Subject: Oyster Creek Nuclear Generating Station  
Docket No. 50-219  
Request for Additional Information for  
Evaluation of Safety Parameter Display  
System (SPDS)

ENCLOSURE

ISOLATION DEVICES--

The attached Seismic Envelope for RIS and TEC, easily exceed the Oyster Creek floor spectra enclosed, which is for 95 ft. elevation, which is worse than the actual elevation used.

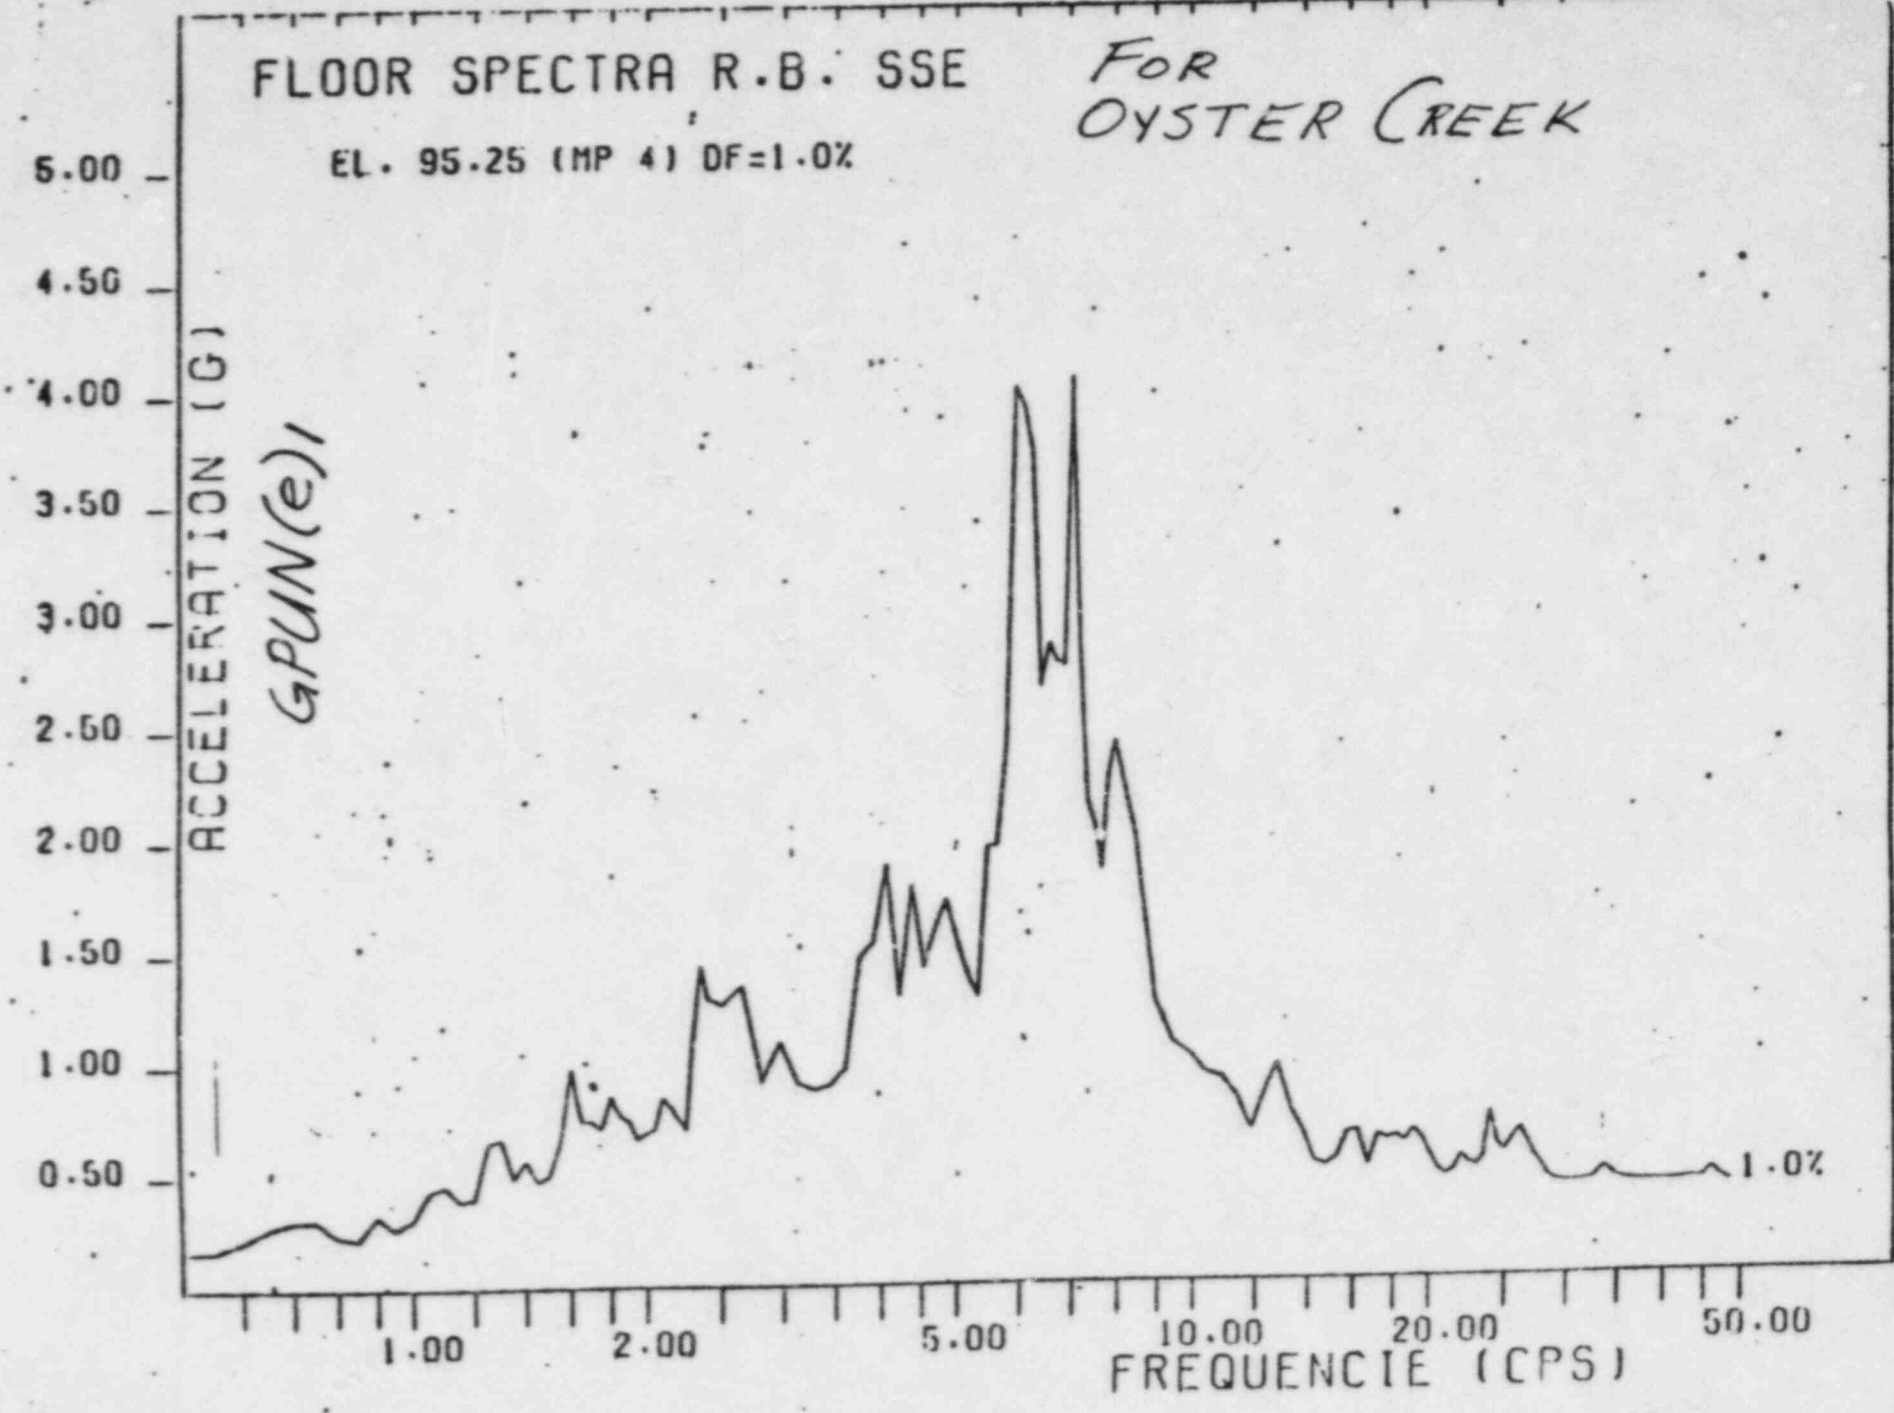
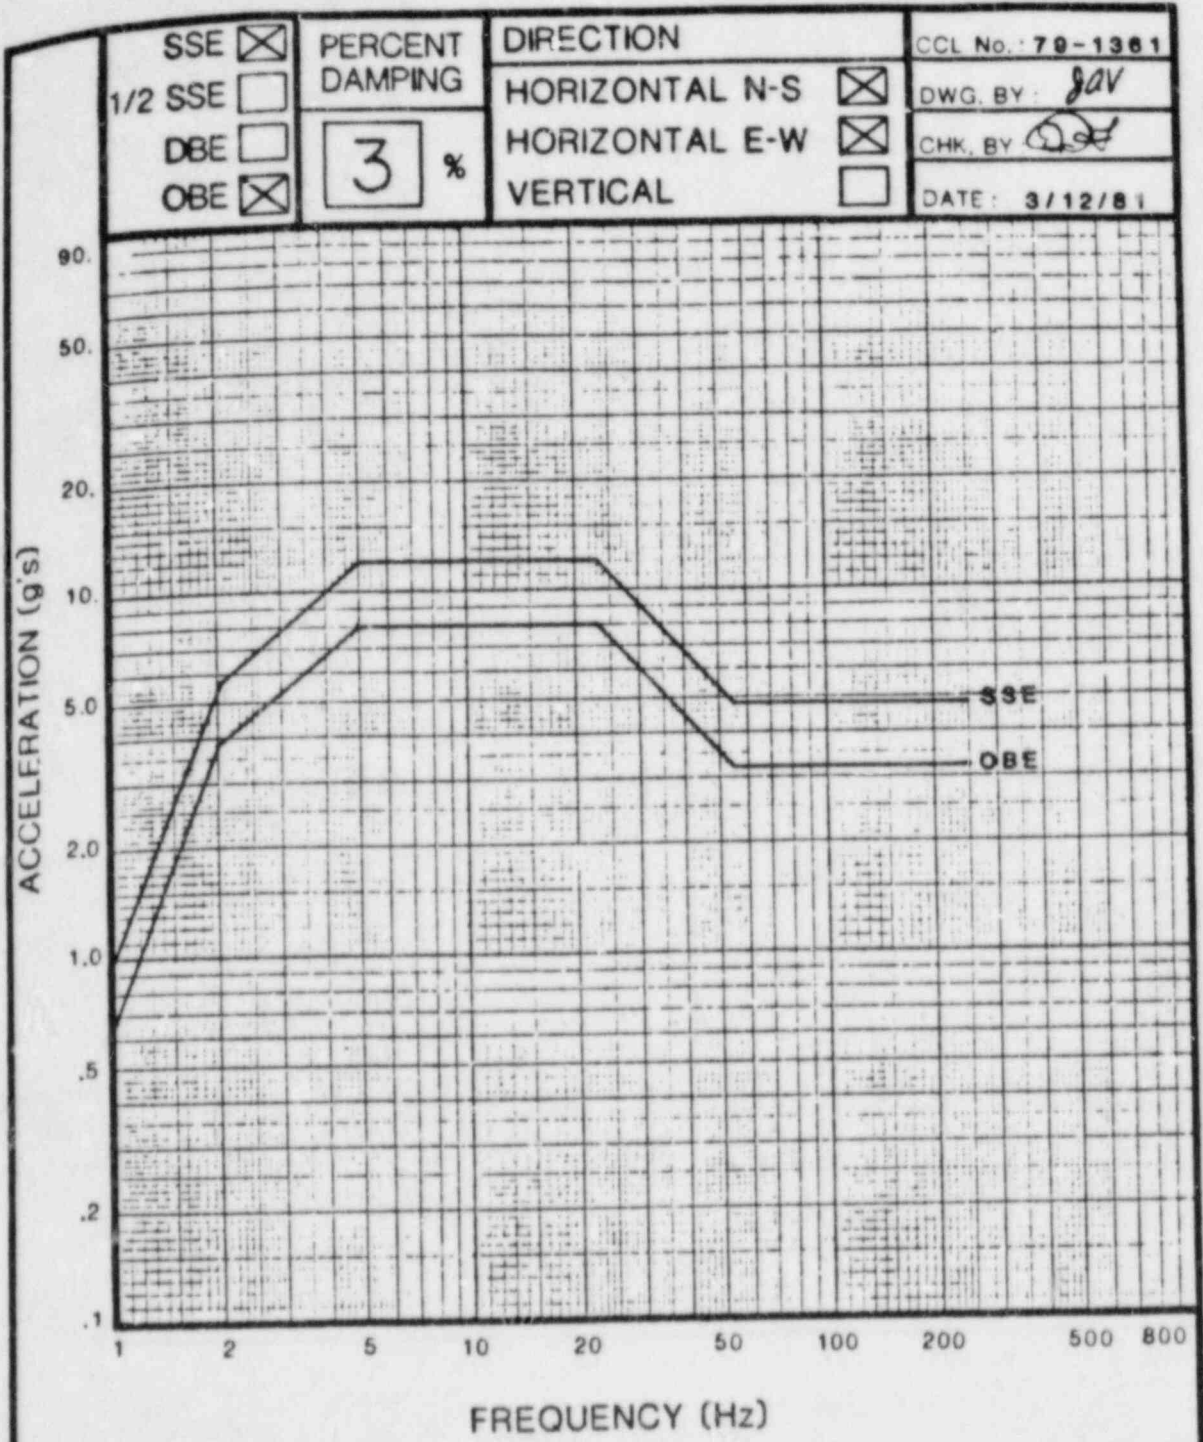
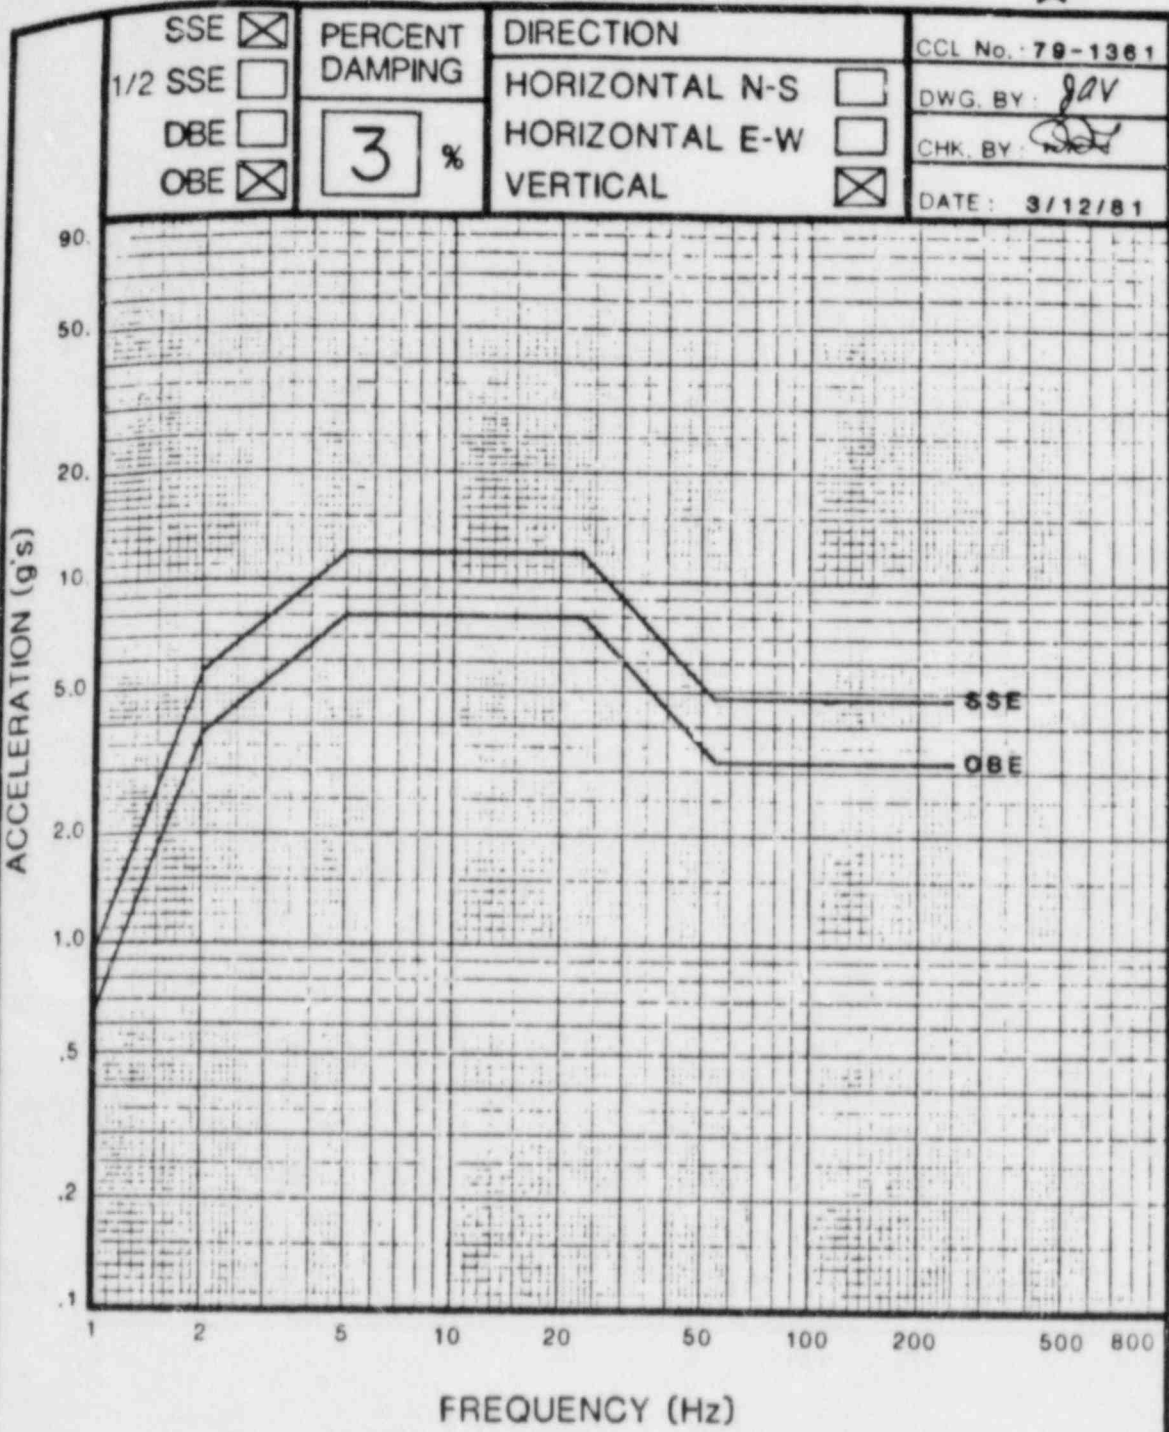
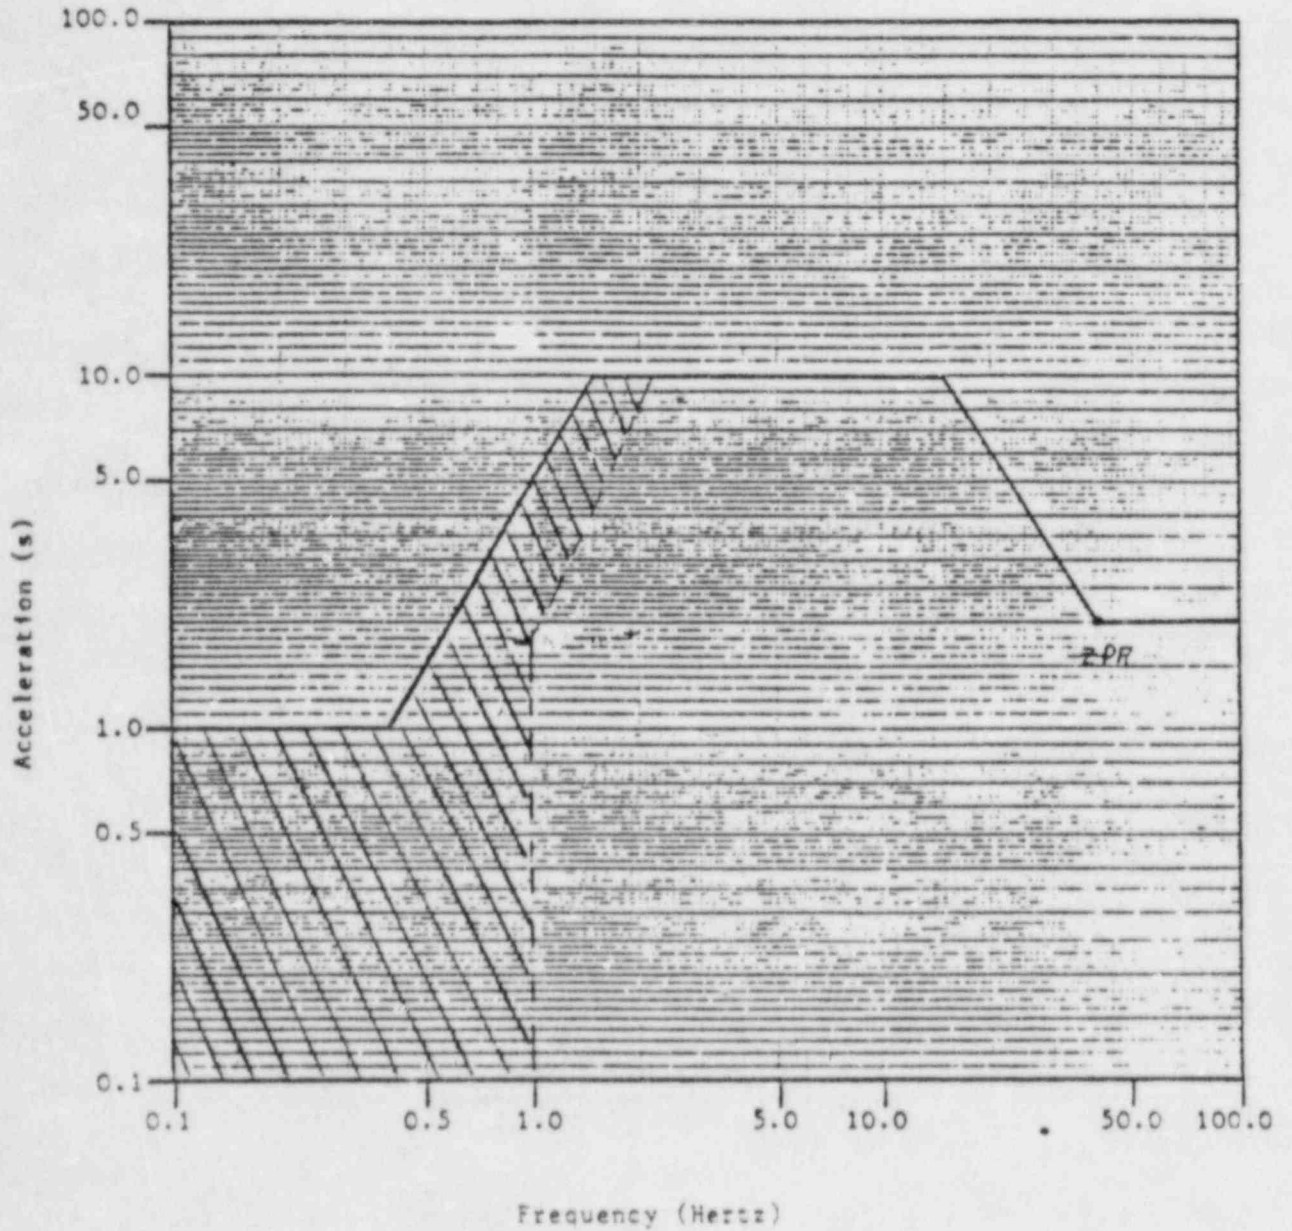
Question e: Provide a commitment that the isolation devices comply with the environmental qualifications (10CFR50.49) and with the seismic qualifications which were the basis for plant licensing.

Response: Although the Isolators used were qualified for Harsh Environments, they are to be used in a mild environment, negating the need to review the environmental testing.
